**COUNTY OF SANTA BARBARA
PLANNING AND DEVELOPMENT**

TO: Honorable Board of Supervisors
FROM: Glenn Russell, Director, Planning and Development
DATE: December 12, 2011
RE: Appeal of Diamond Rock CUP Revision

Re: Letter Attachment from Dr. R. Curry, dated June 2, 2011

INSTREAM-MINING - DIAMOND ROCK MINE

Fig 1 FEIR Fig 3.3 Flow and Drainage Diamond Rock Pit site

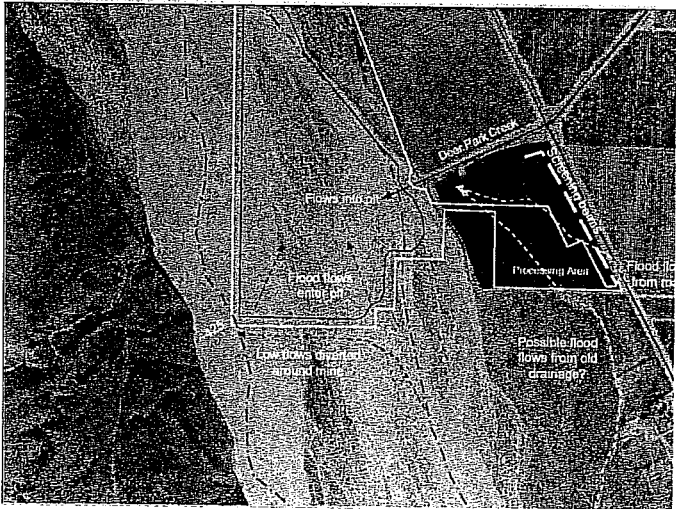
Pages 3-4 discuss the larger erosion banks located on the south side of the river generally near the southwest corner of the Diamond Rock project. The second full paragraph on page 3 states that the GPS pit is causing this erosion, and that the Diamond Rock project will contribute to it. Figure 3-3 from the Final EIR is presented to illustrate this point.

This is a portion of the EIR's Figure 3.3 "Flow and Drainage": Plates 1 & 2 are taken about 900 feet upstream (south) where the blue dot-dash line is shown against the cliff face in their figure.

The FEIR would somehow have us believe that the “low flow diversion channel” would pass harmlessly around the Diamond Rock mine pit. In fact, if flows are diverted successfully around the pit, they will continue to actively erode the cliff-face shown in Plate 1. If those flows are diverted to enter the southwest corner of the pit, the accelerated downcutting of the river bed will under-cut and further destabilize the high unconsolidated bank, filling the GPS pit with silt and increasing the filling of the Twitchell Reservoir.

Figure 3-3 from the Diamond Rock Final EIR, cited by Dr. Curry, shows what was proposed by the applicant with respect to low flow diversion, and shows the configuration that would occur only at the final phase of excavations there. While we disagree with the severity of the issue, we had the same concern expressed by Dr. Curry and describe the potential for increased erosion from this configuration in Section 3.1.2.2.1 of the Final EIR. Our "suggested condition" W-1 shows an alternate design to be used throughout most of the project lifetime. This is shown in Figure 3-8. The low flow diversion berms are intended to control only low flows. They will not control floods, they will not prevent surface water from entering the pits during large storms, nor will they prevent the existing natural erosion that is occurring along the southern bank.

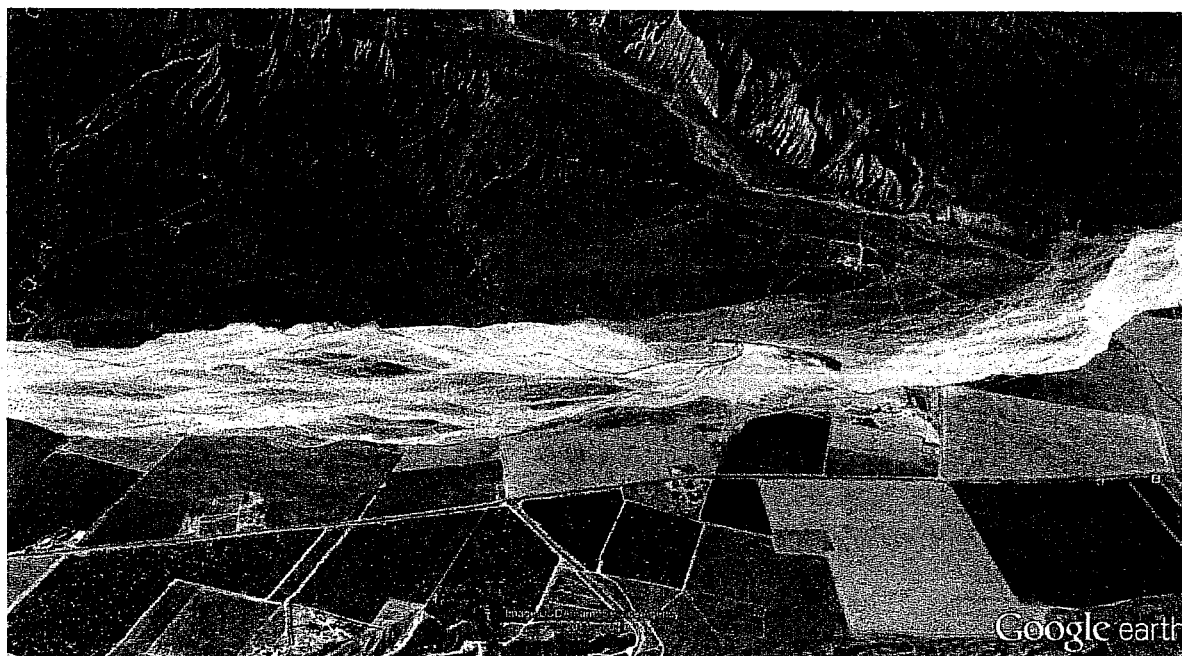
It is very hard to understand how the statement quoted above from the EIR at 3.1-19 could be considered as anything other than false. This collapsing cliff has been active since at least the 1998 floods and is clearly visible from Highway 33. It is pictured from the highway in a photo on the USGS Cuyama water website at: http://ca.water.usgs.gov/projects/cuyama/images/pics/Geology/IMG_0894.JPG An aerial overview that I have created from Google Earth Pro USDA Farm Services Agency aerial photos of May 24, 2009 follows:

PLATE 1 40+ FOOT HIGH ACTIVE CUT BANK 3400 FT UPSTREAM FROM THE GPS MINE PIT

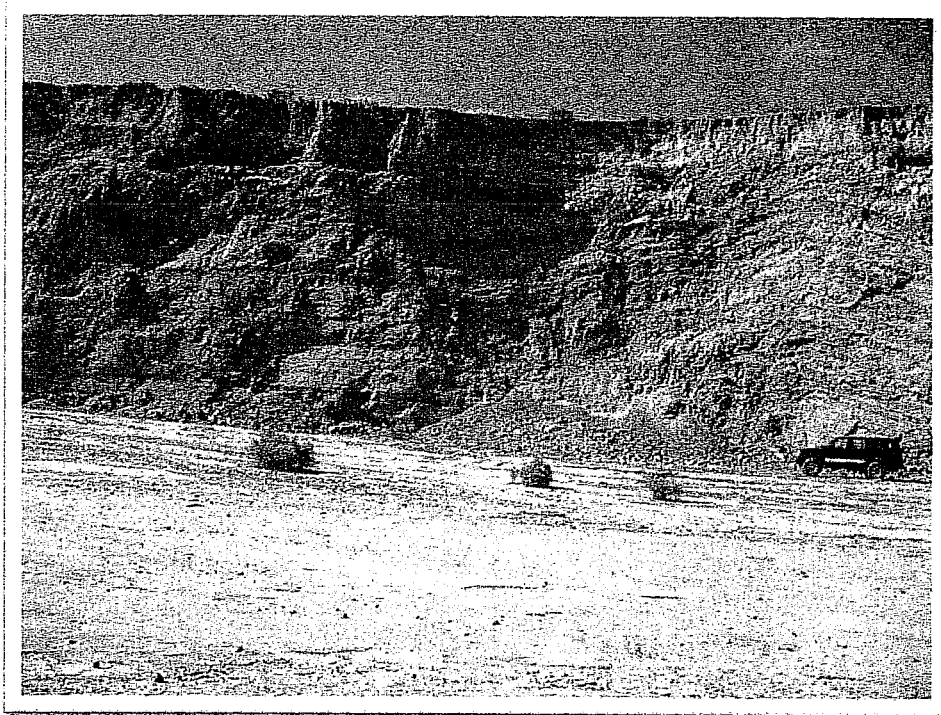
Channel bank cutting is episodic even in the lower Cuyama Valley, as in fact must be sedimentation in the Reservoir. Observations of changes in the southwest riverbank near the mine site indicate continuing contemporary bank cutting and slumping. Comparing ground photographs taken in November, 2011 with those taken as recently as January, 2009⁴, we see oversteepened 40-foot high riverbanks slumping into the active Cuyama River channel (Plates 1 & 2 of this report). This site is noted as “tightly folded and faulted Tertiary-aged Quatal Formation overlain by older alluvium”⁵ outcropping along the south side of the Cuyama River in the Upper Cuyama River Valley.
